Project	<b>IEEE 802.16 Broadband Wireless Access Working Group</b> < <a href="http://ieee802.org/16">http://ieee802.org/16</a> >
Title	<b>Sleep Mode Statistics</b>
Date Submitted	<del>2006-04-18</del>
Source(s)	Joey Chou <a href="mailto:joey.chou@intel.com">[mailto:joey.chou@intel.com]</a> Intel Corporation 5000 W. Chandler Blvd. Chandler, AZ 85226
Re:	
Abstract	This contribution proposed the text and ASN.1 code for Sleep mode Statistics objects.
Purpose	Adoption
Notice	This document has been prepared to assist IEEE 802.16. It is offered as a basis for discussion and is not binding on the contributing individual(s) or organization(s). The material in this document is subject to change in form and content after further study. The contributor(s) reserve(s) the right to add, amend or withdraw material contained herein.
Release	The contributor grants a free, irrevocable license to the IEEE to incorporate material contained in this contribution, and any modifications thereof, in the creation of an IEEE Standards publication; to copyright in the IEEE's name any IEEE Standards publication even though it may include portions of this contribution; and at the IEEE's sole discretion to permit

19 **Figure 7— wmanIfBsCps structure**

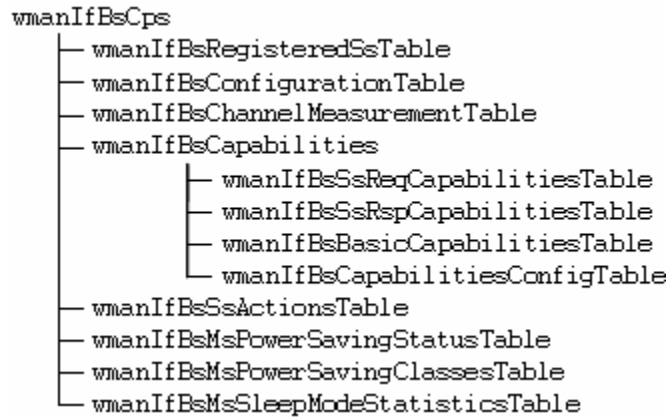
7 This section proposes new table for Sleep Mode Statistics.

9 *[Replace Figure 7 in subclause 15.2.1.1.2 with the following:]*
